**FINAL DRAINAGE REPORT
FOR
STERLING RANCH FILING NO. 5**

March 2024

**Project No. 25188.16
PCD Filing No: SF-241**

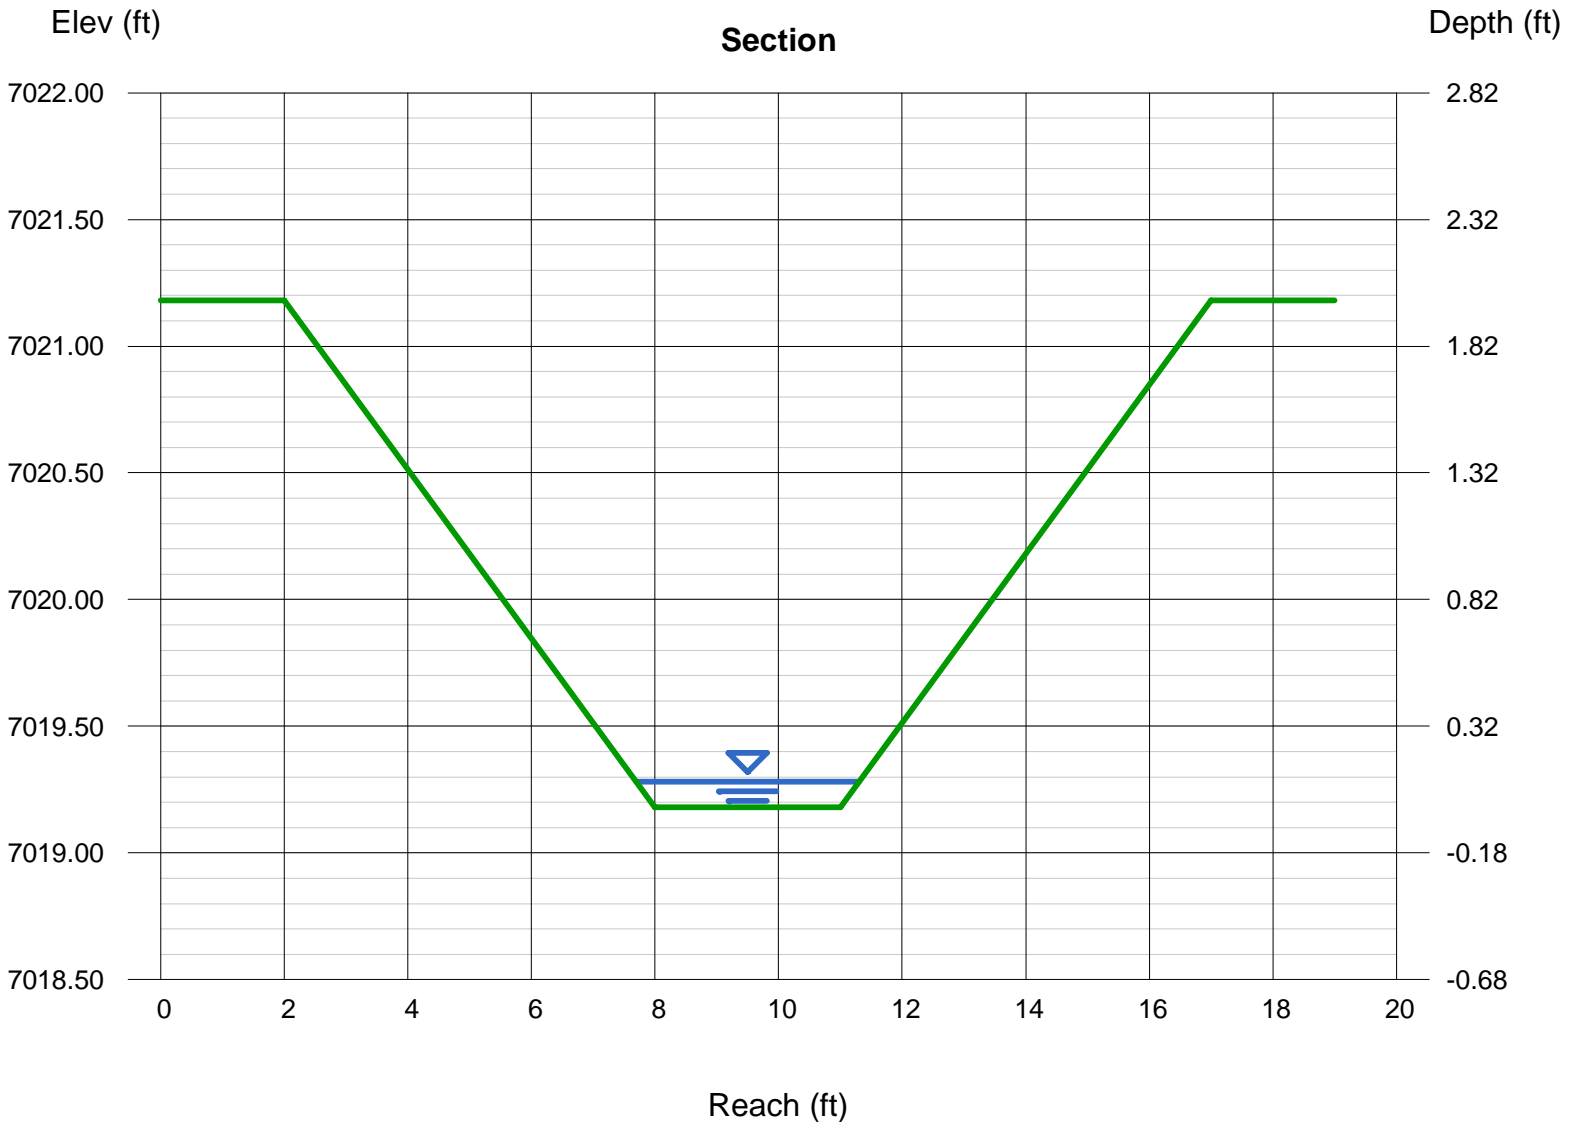
Highlighted information does not match with information channel detail in GEC Plan set

EMERGENCY POND OVERFLOW EXHIBIT
STERLING RANCH FILING NO. 5
JOB NO. 25188.16
03/11/24
SHEET 1 OF 1

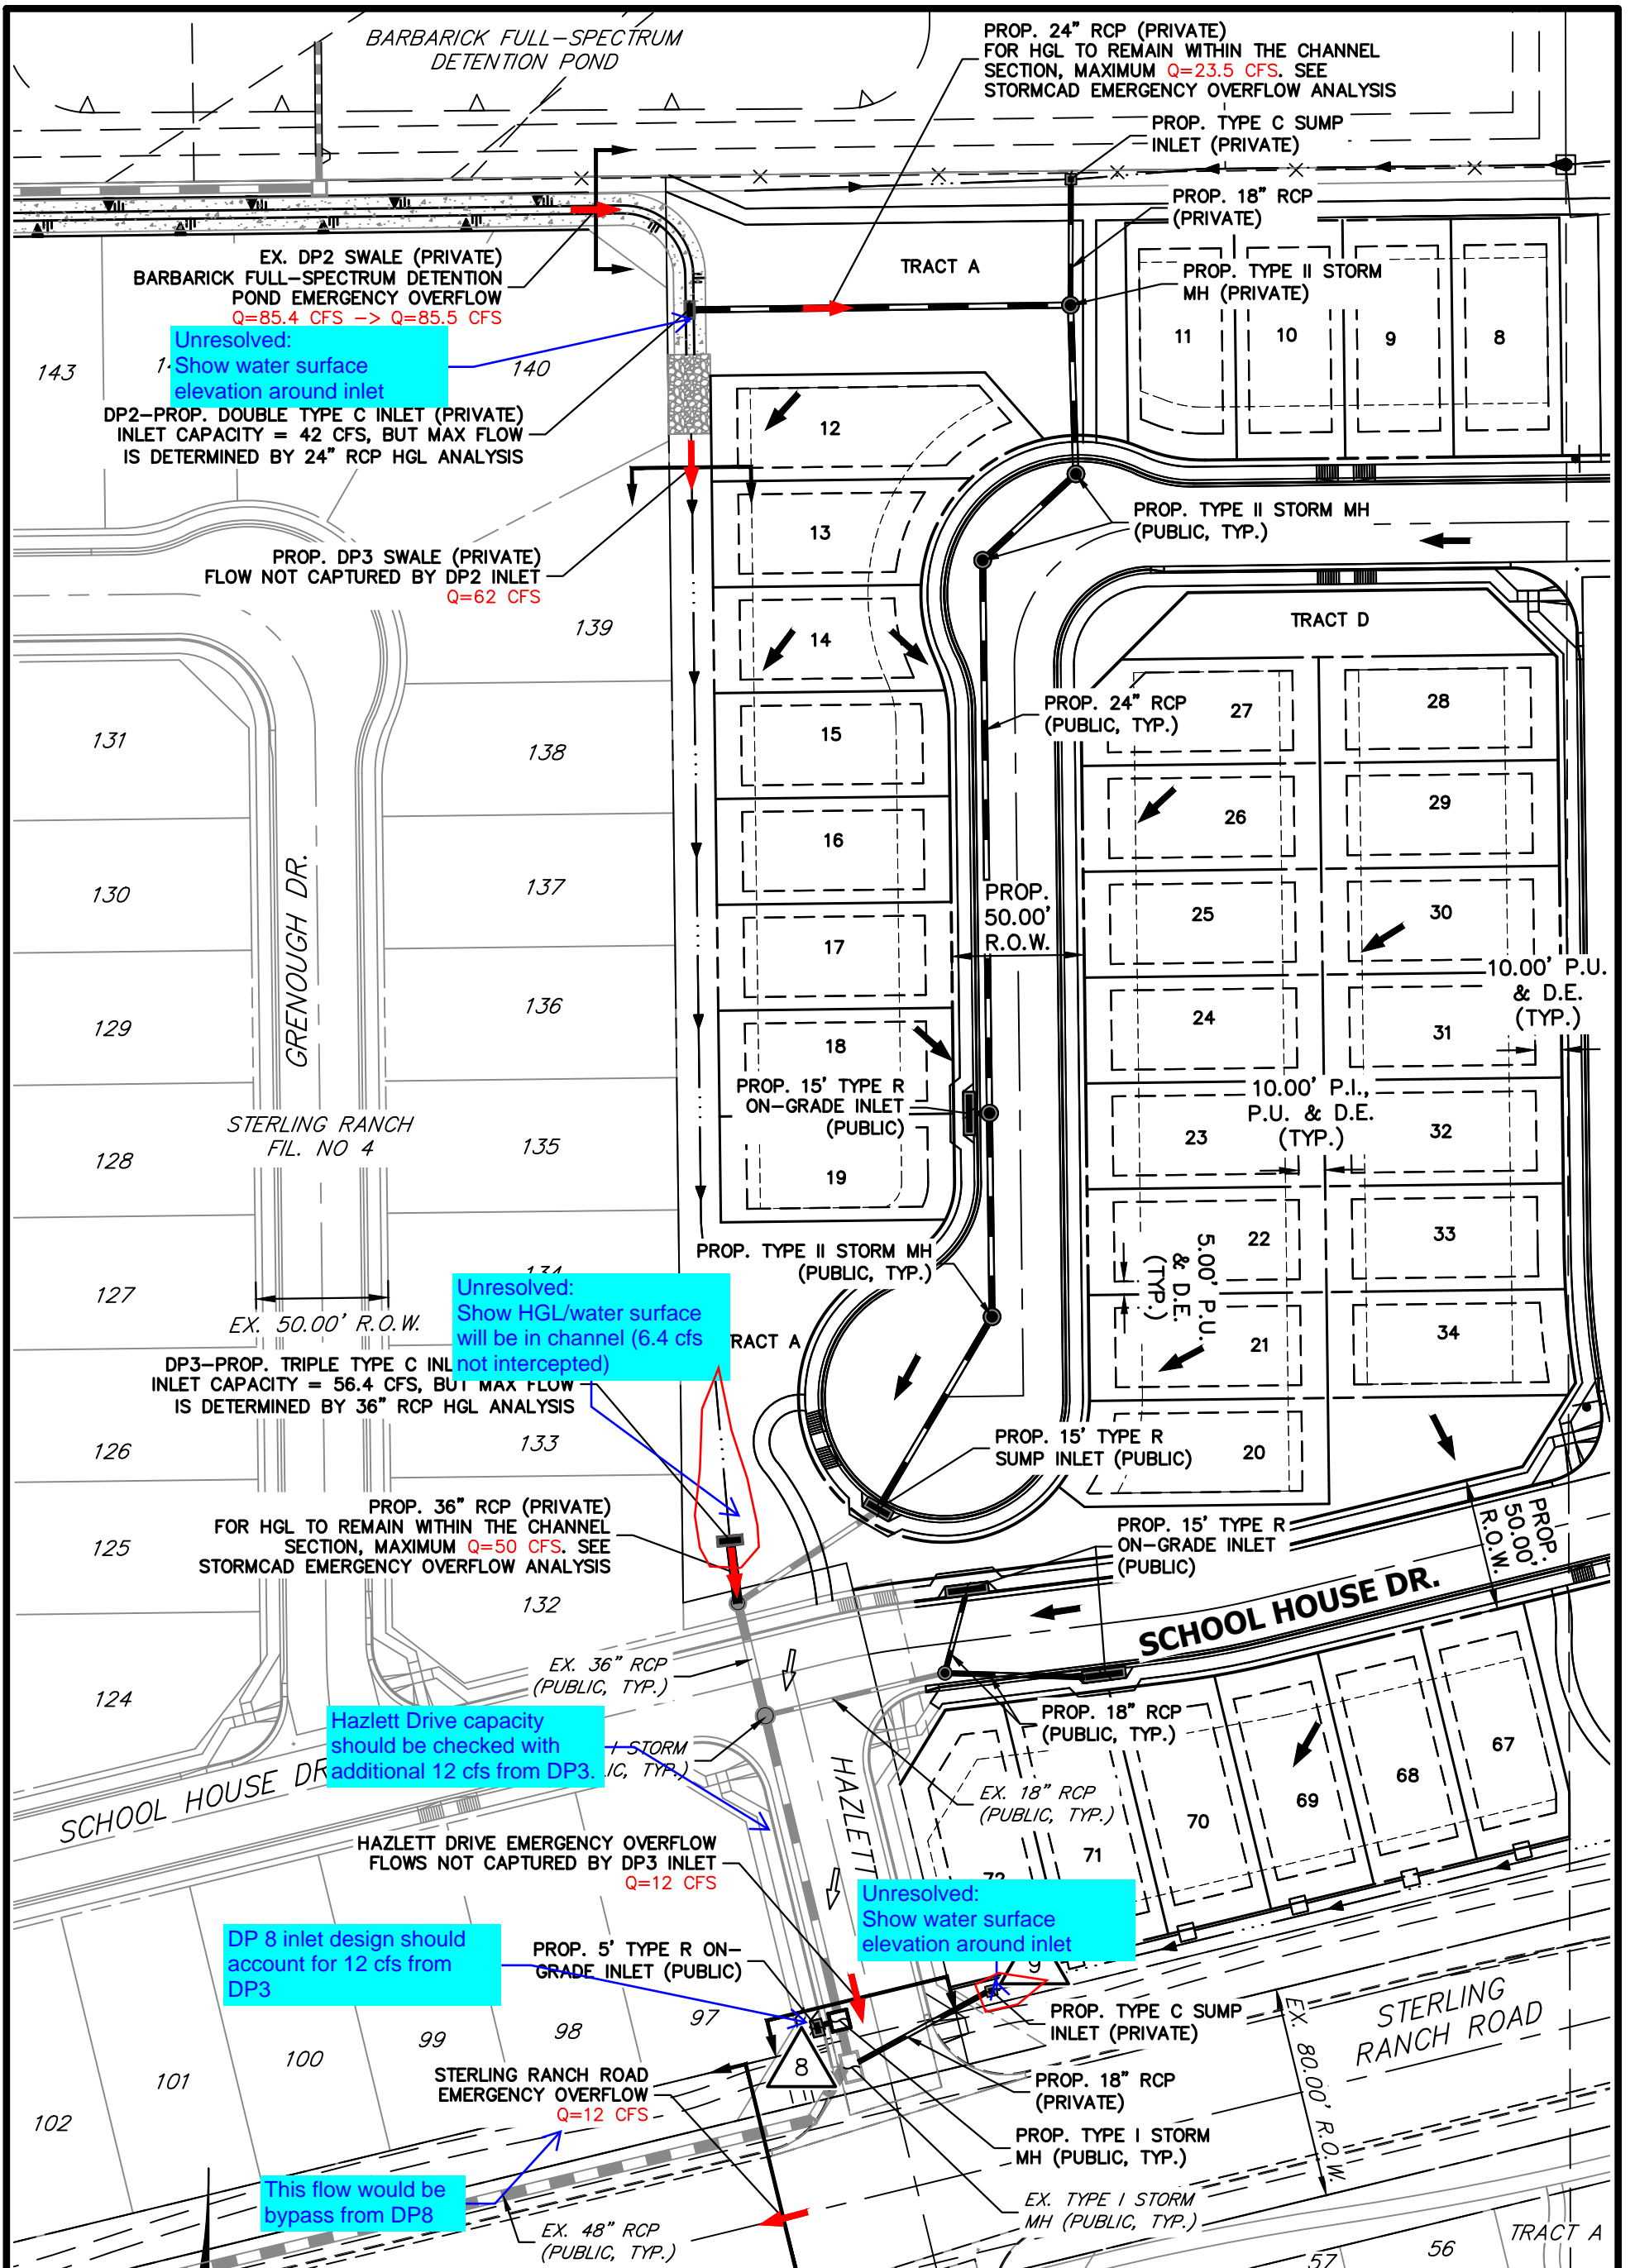
Unresolved:
1- Show water surface elevation around inlet

Unresolved:
Show HGL/water surface will be in channel (6.4 cfs not intercepted)

Unresolved:
Show water surface elevation around inlet

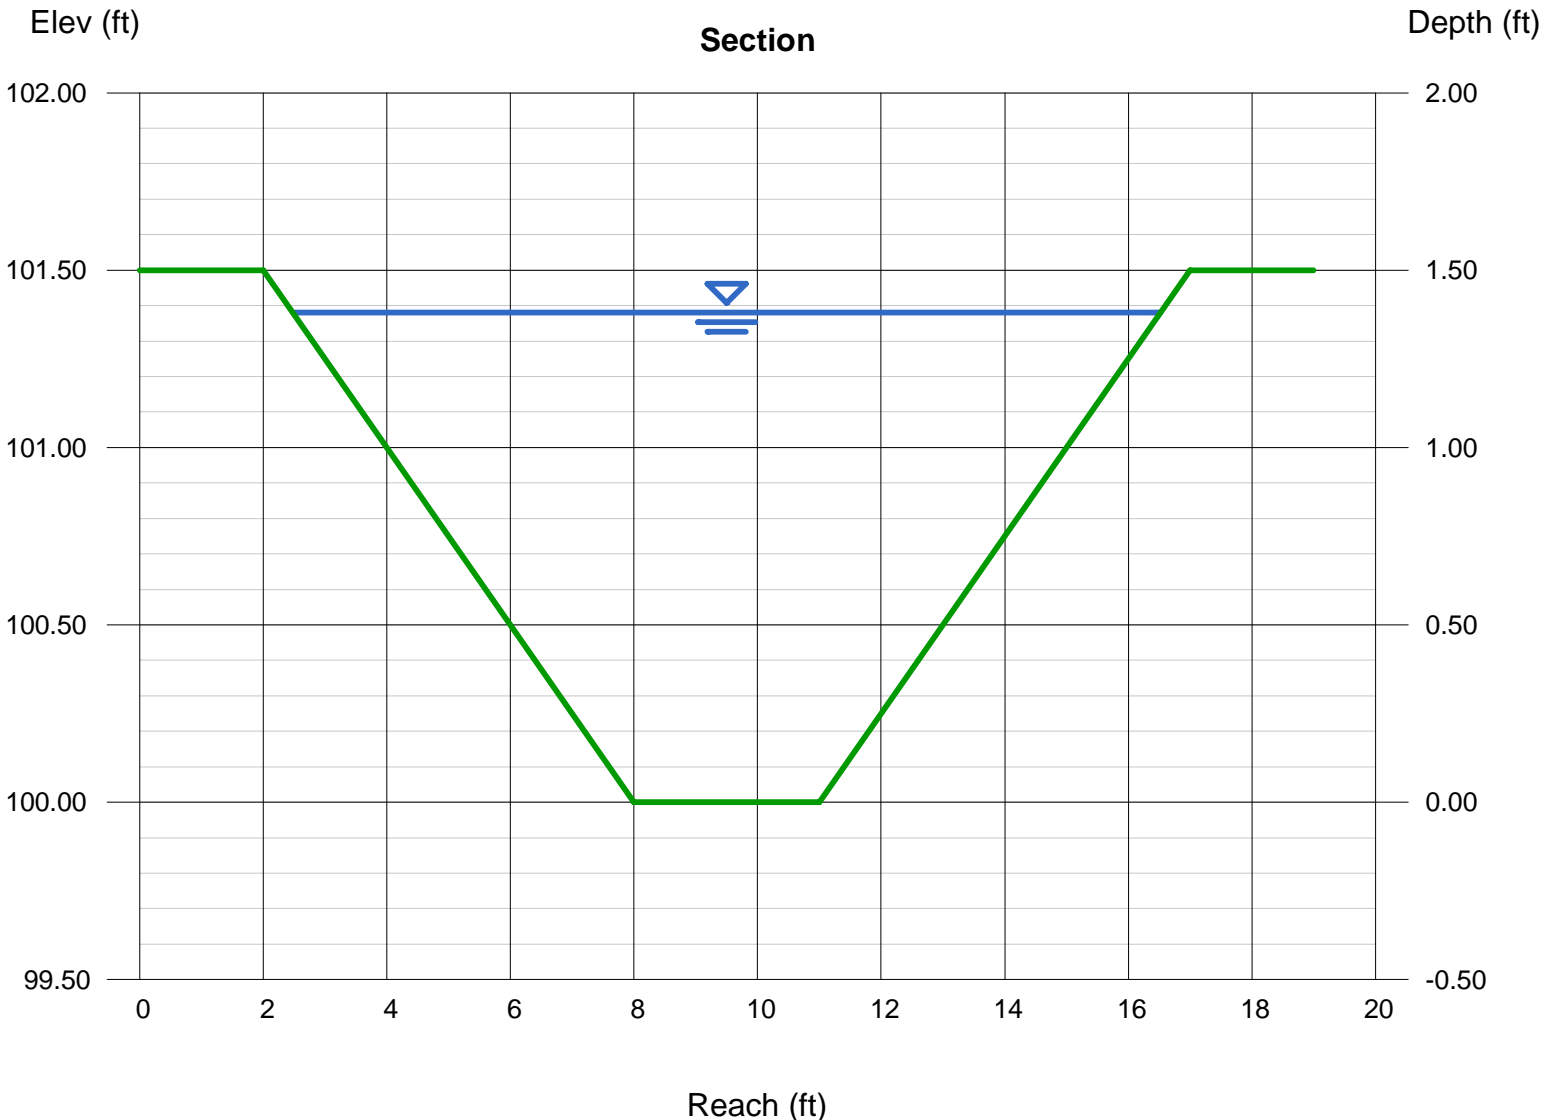
Run a worst case scenario on this channel (82.5 cfs) to show what happens if inlets are clogged. Provide small discussion within report.

SUMP INLET EMERGENCY OVERFLOW EXHIBIT
STERLING RANCH FILING NO. 5
JOB NO. 25188.16
03/11/24
SHEET 1 OF 1

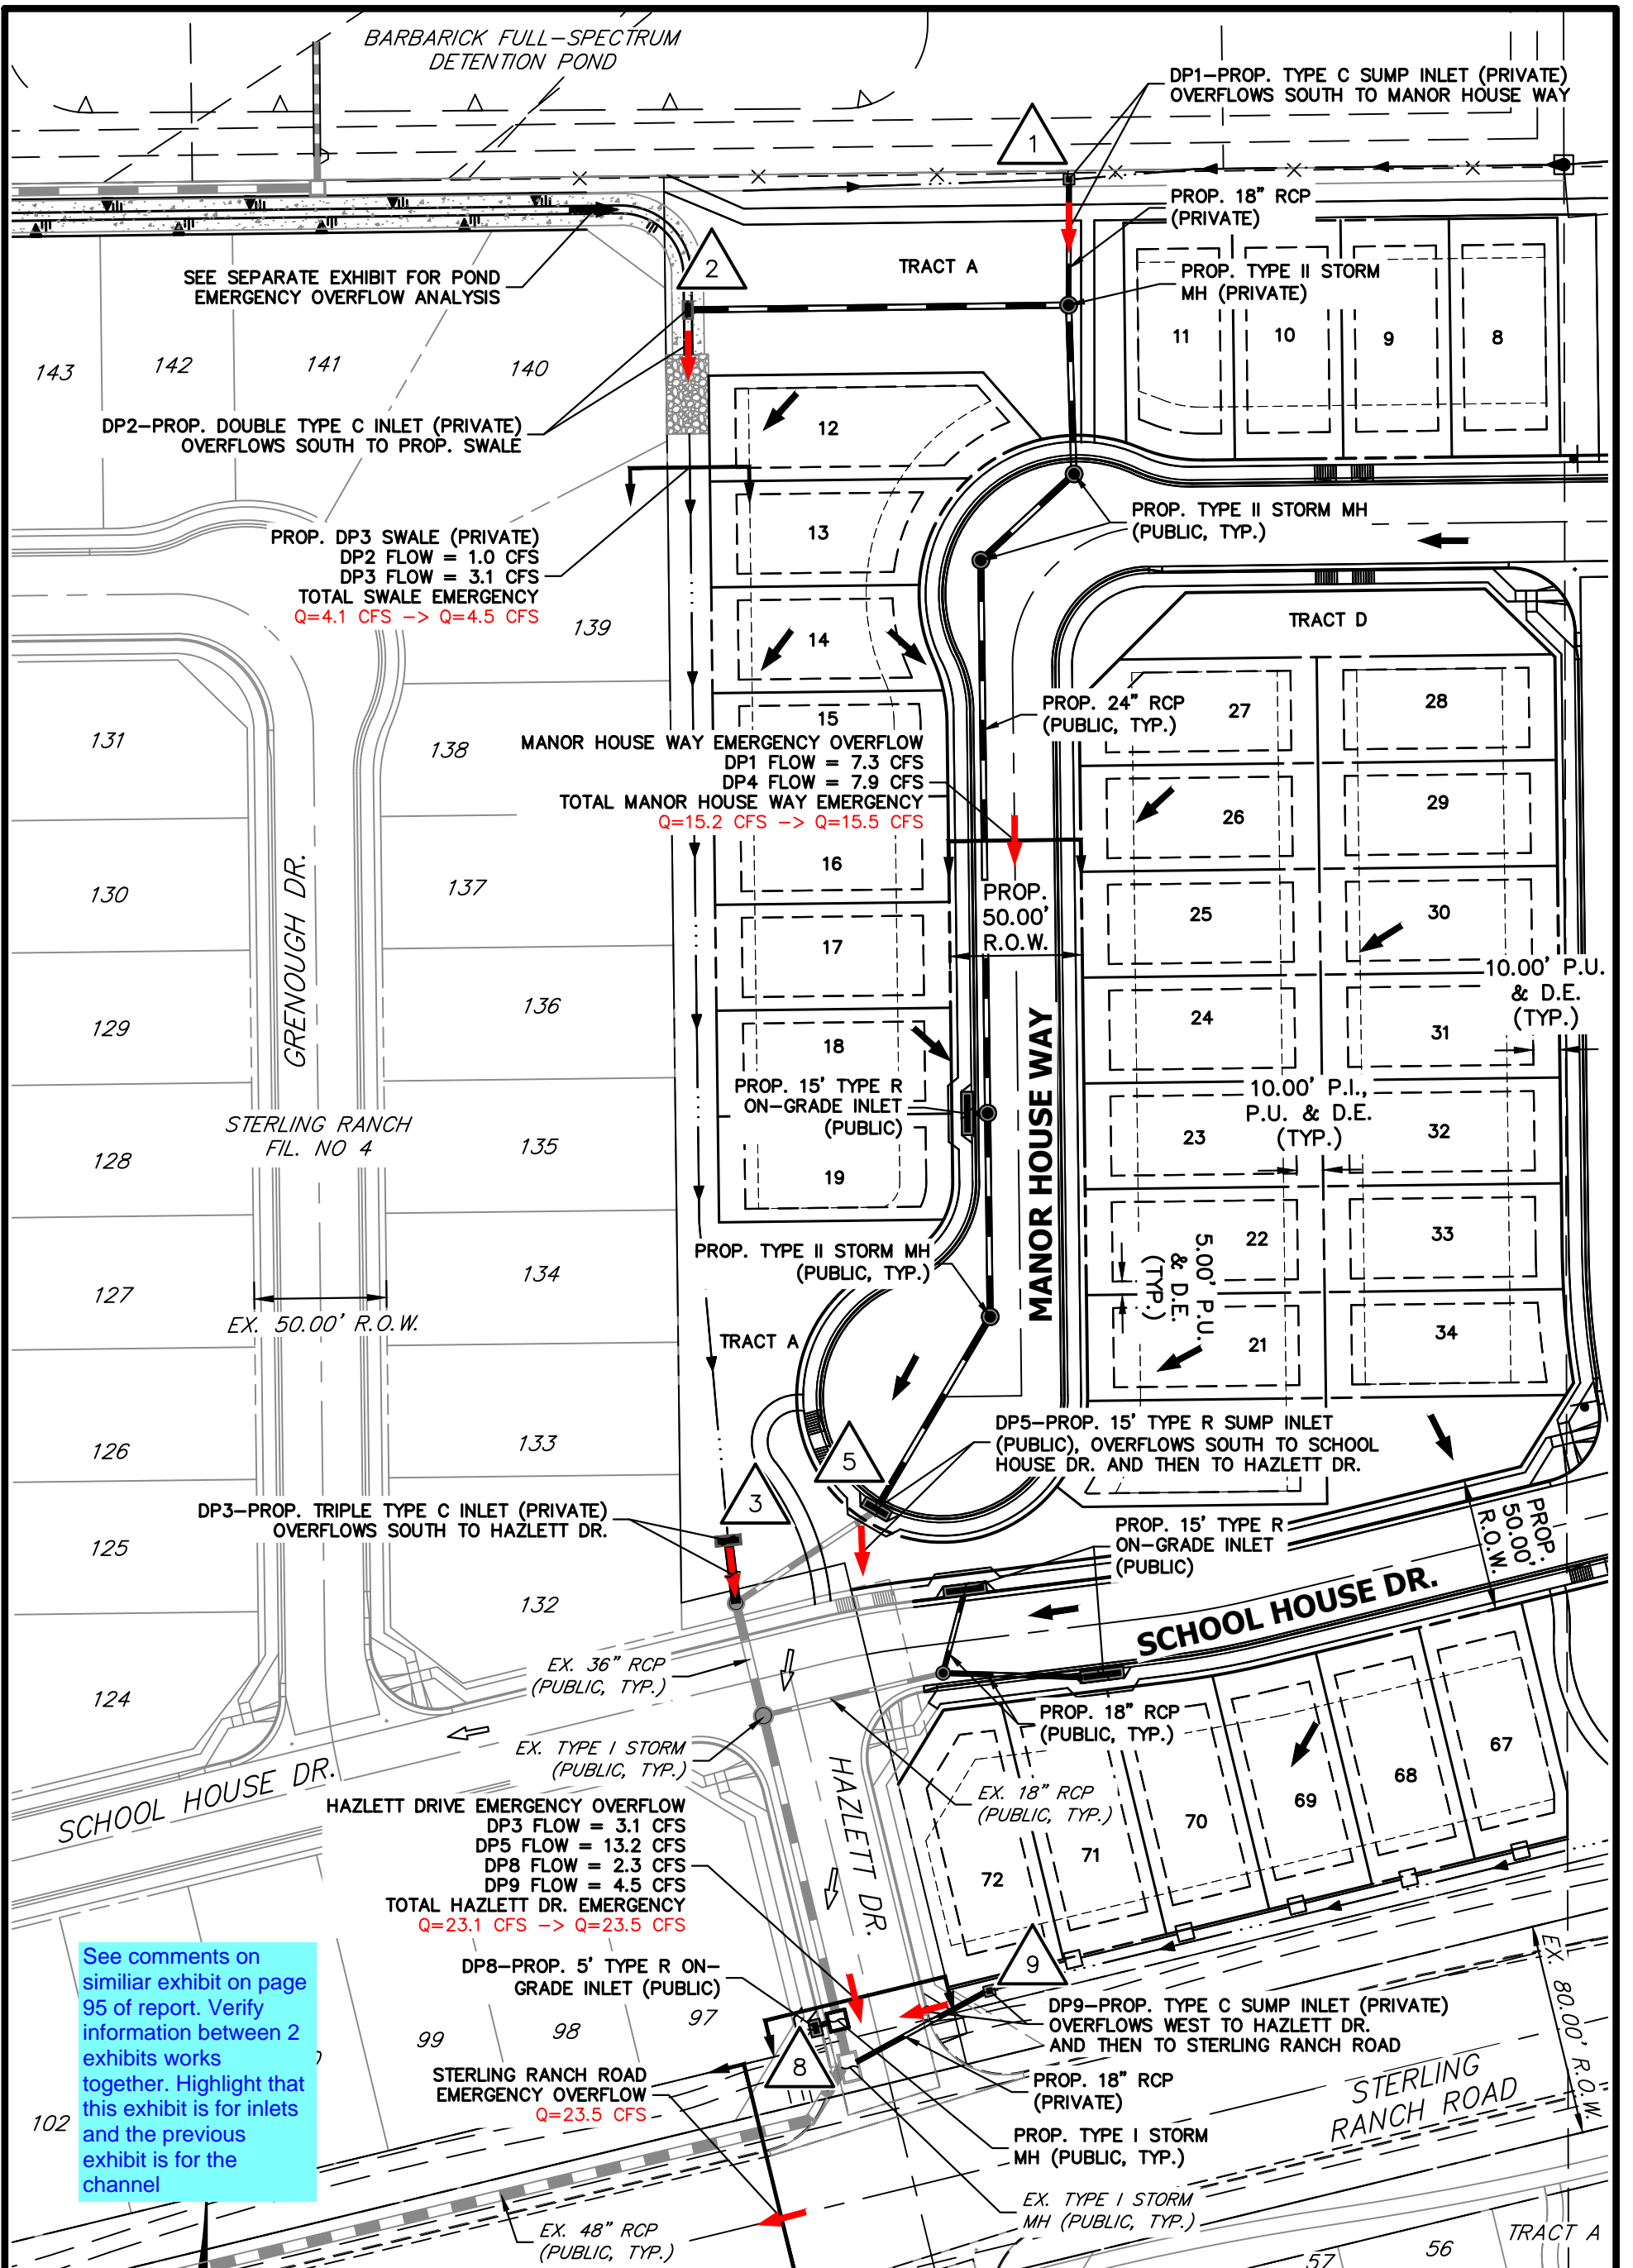
See comments on similar exhibit on page 95 of report. Verify information between 2 exhibits works together. Highlight that this exhibit is for inlets and the previous exhibit is for the channel
